CONSTRUCTION DOCUMENTS

FALCON MARKETPLACE

SF-19-001

75% SUBMITTAL 12-20-18

SECTION C-C
NO SCALE

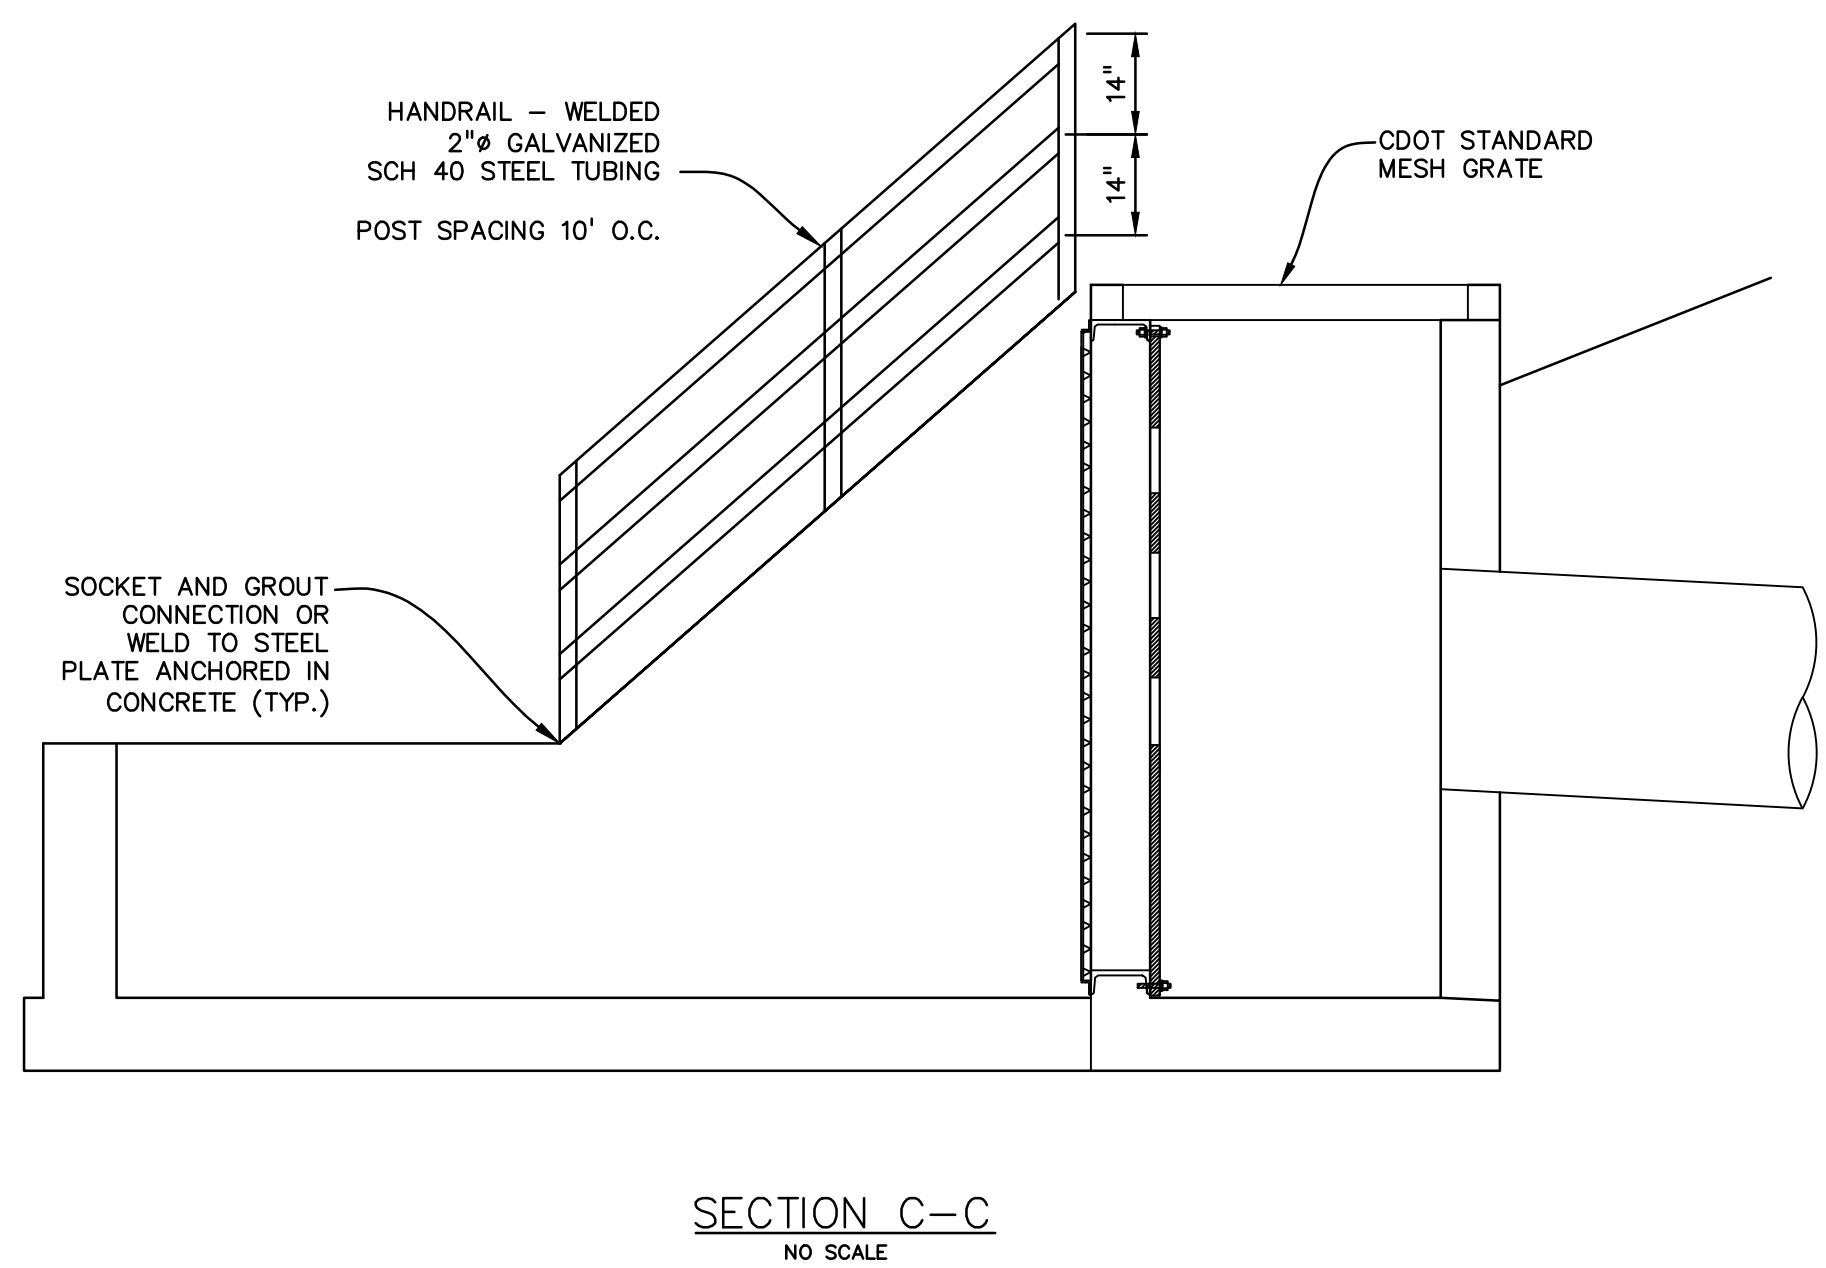
Stainless steel?

POND #3 & DETAILS

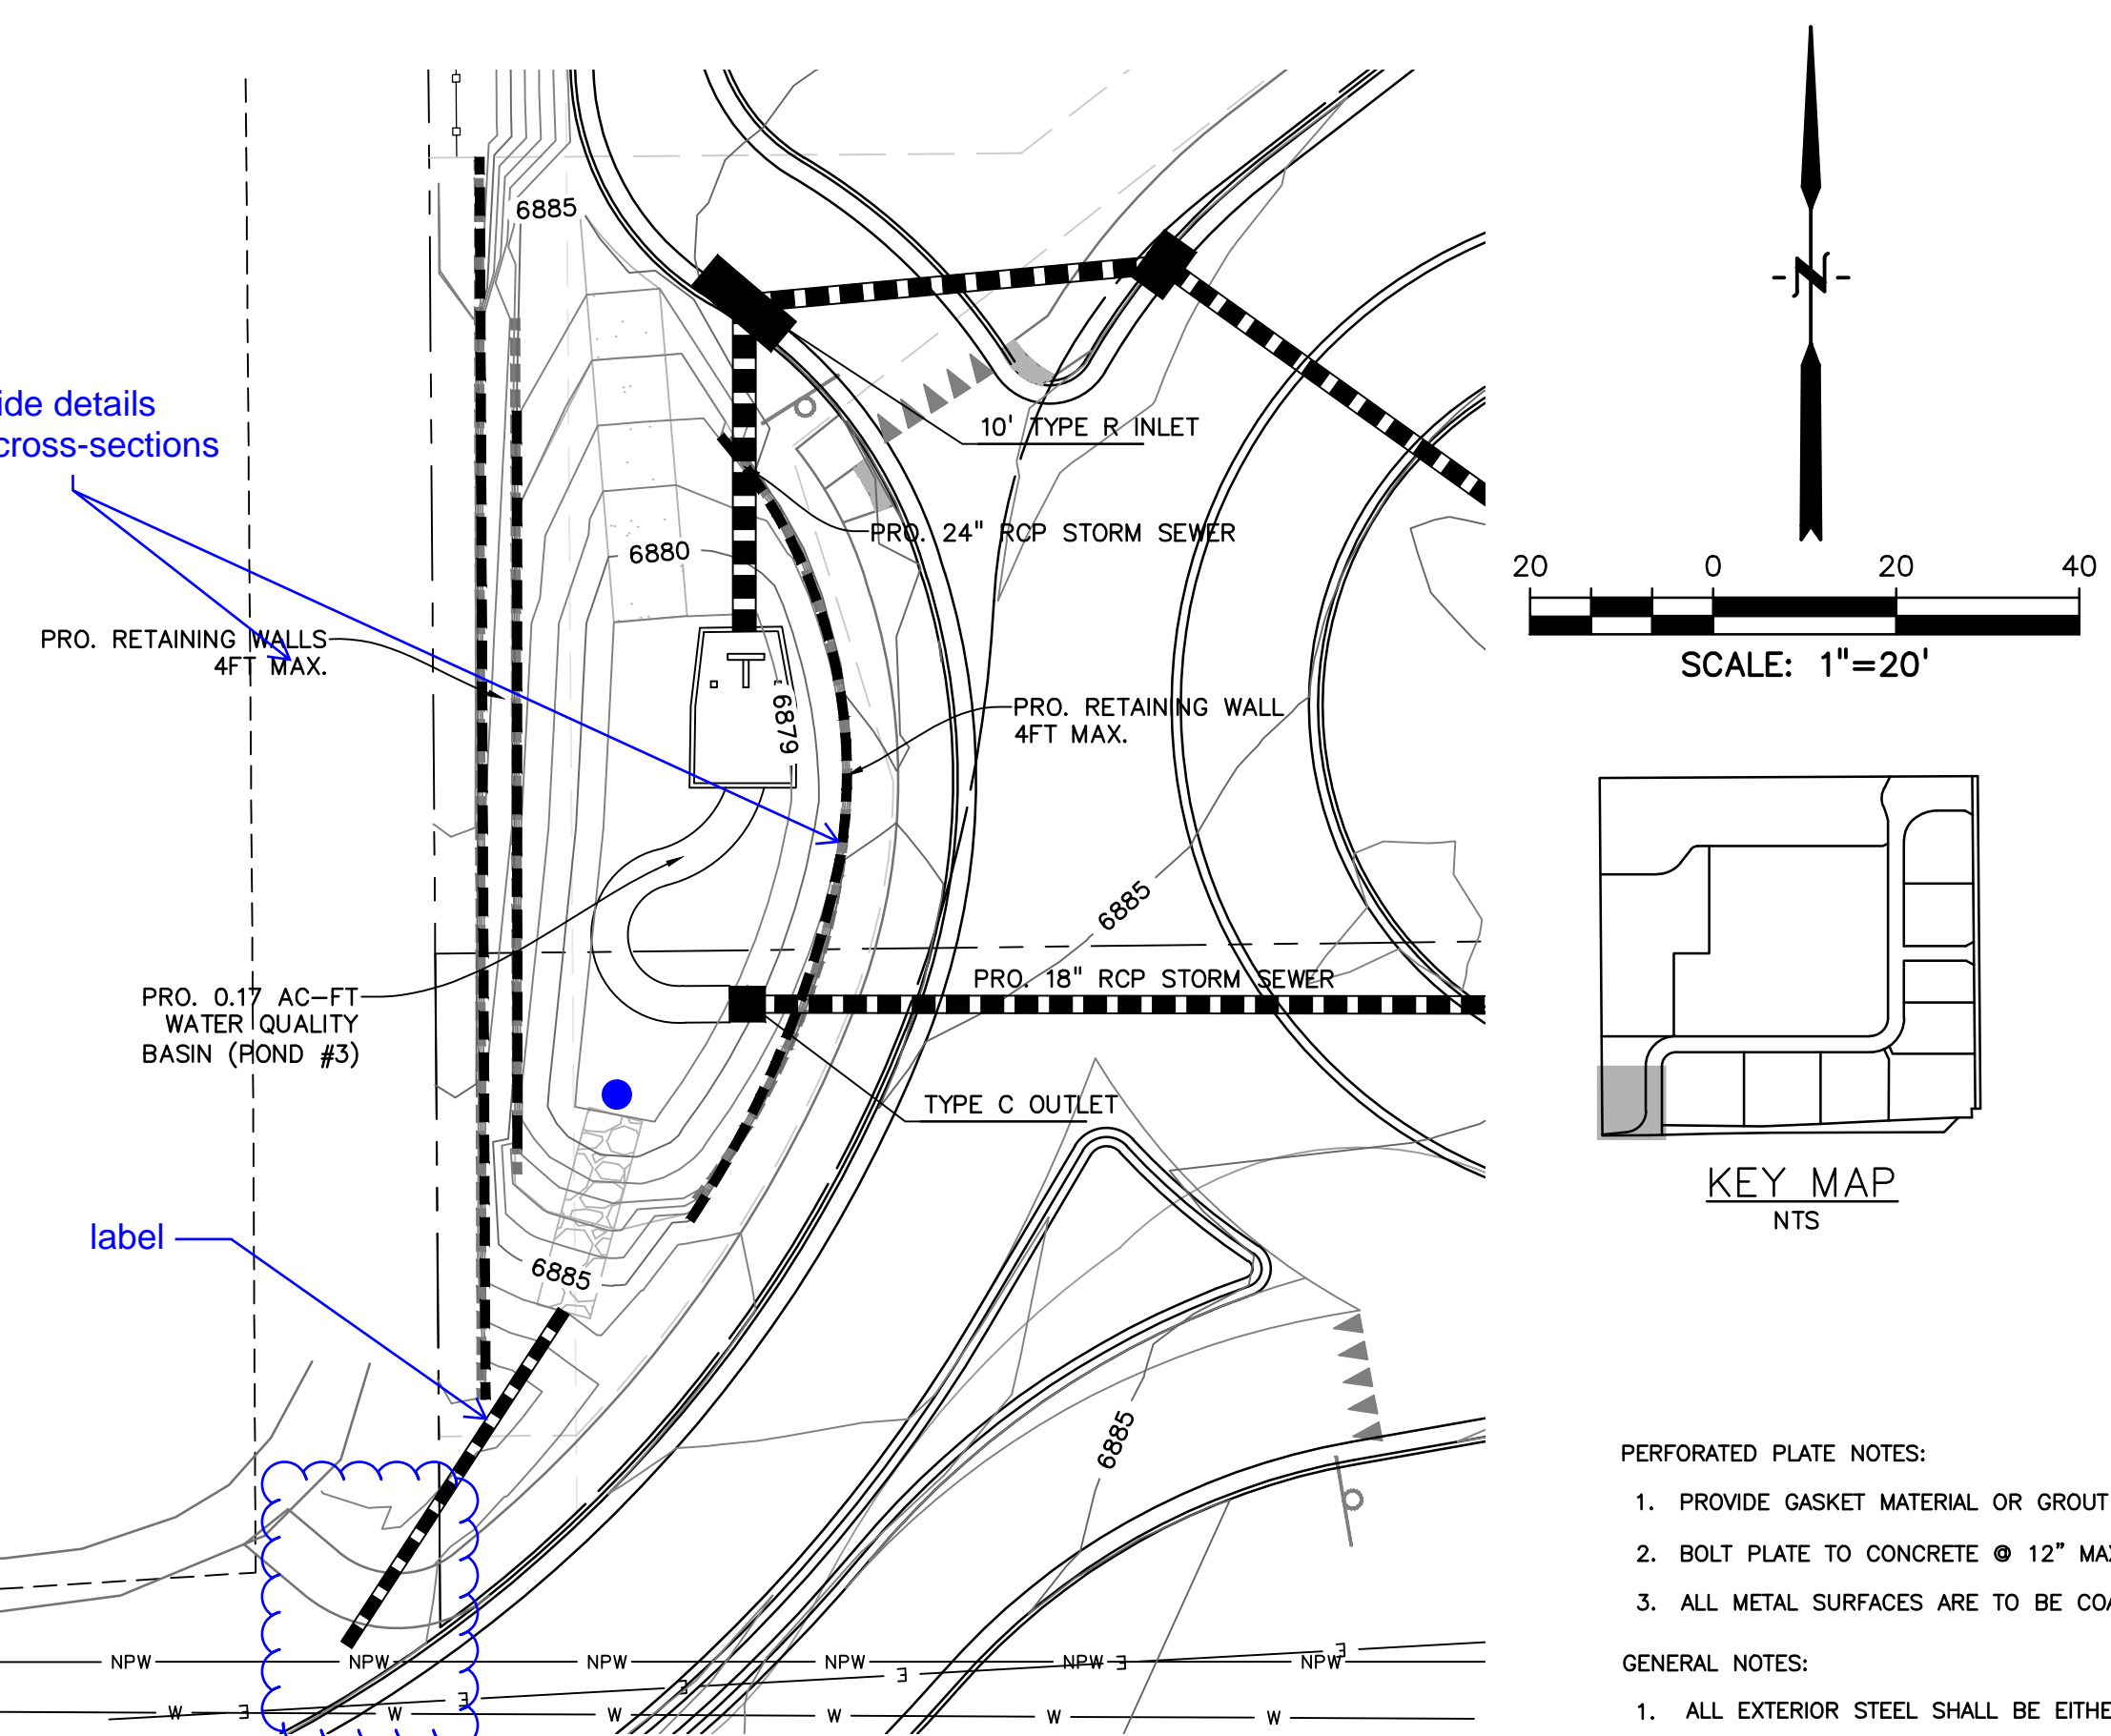
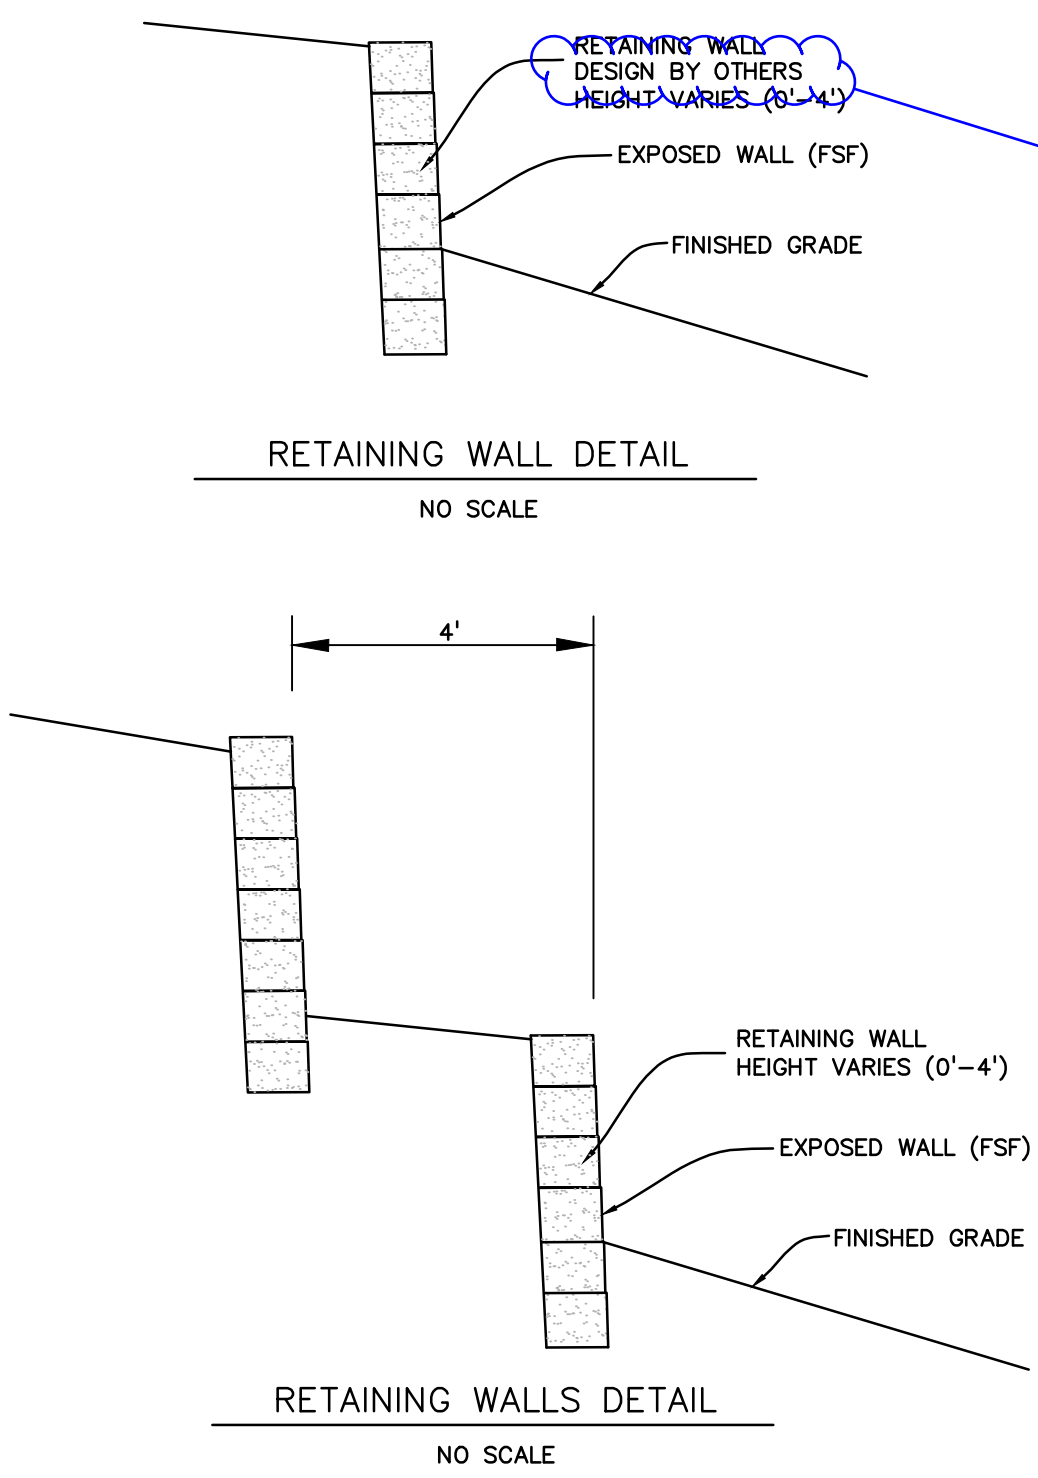
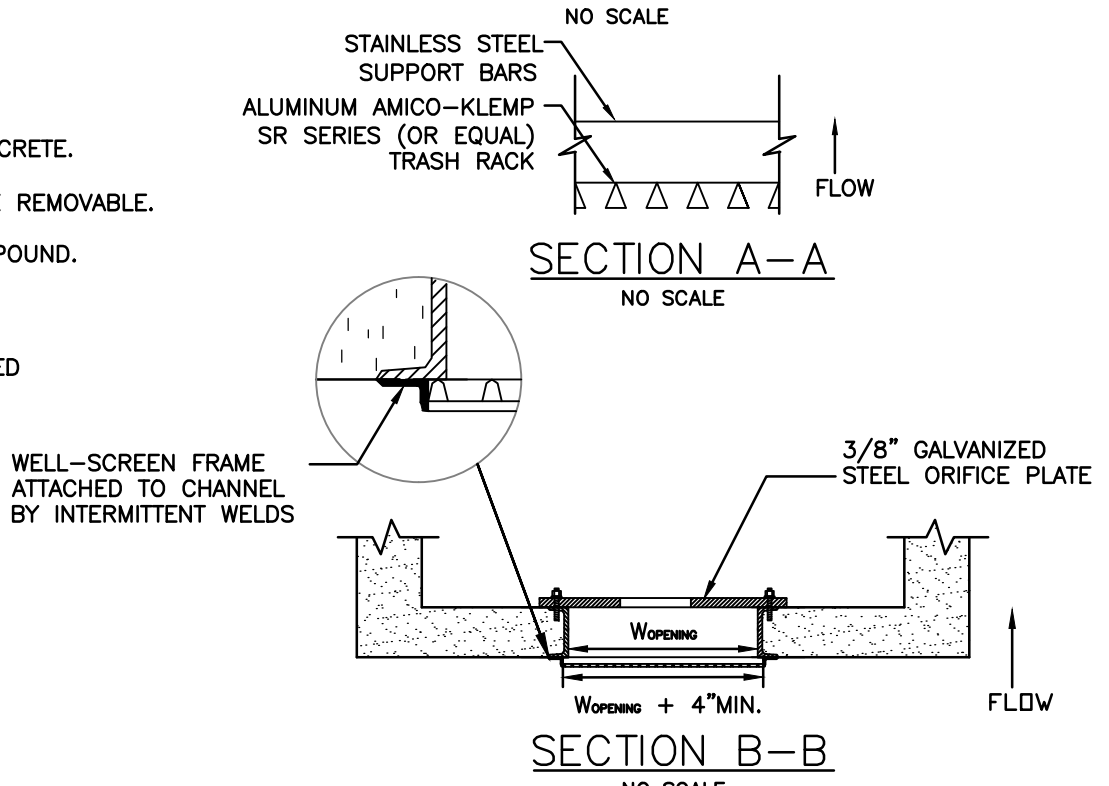
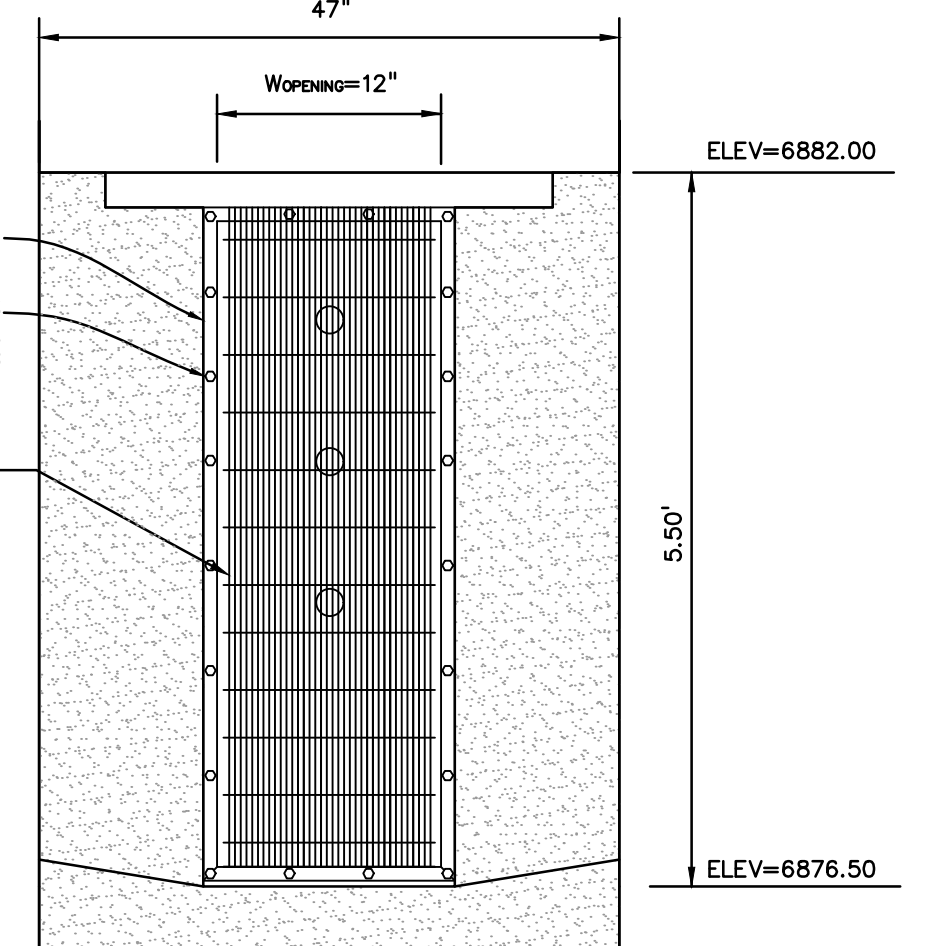
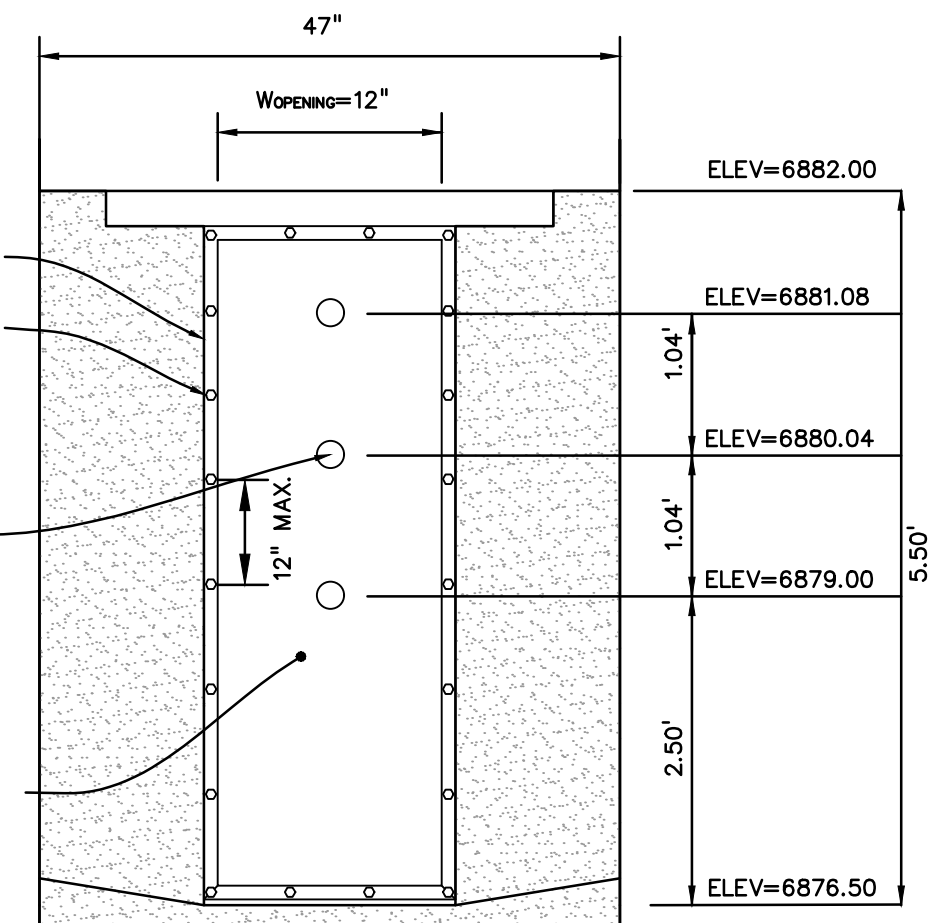
This doesn't make sense. Split the inlet or provide a micropool before the well screen. Reference UDFCD Volume 3, T-12 page OS-11.

Provide details and cross-sections

provide detail

Provide
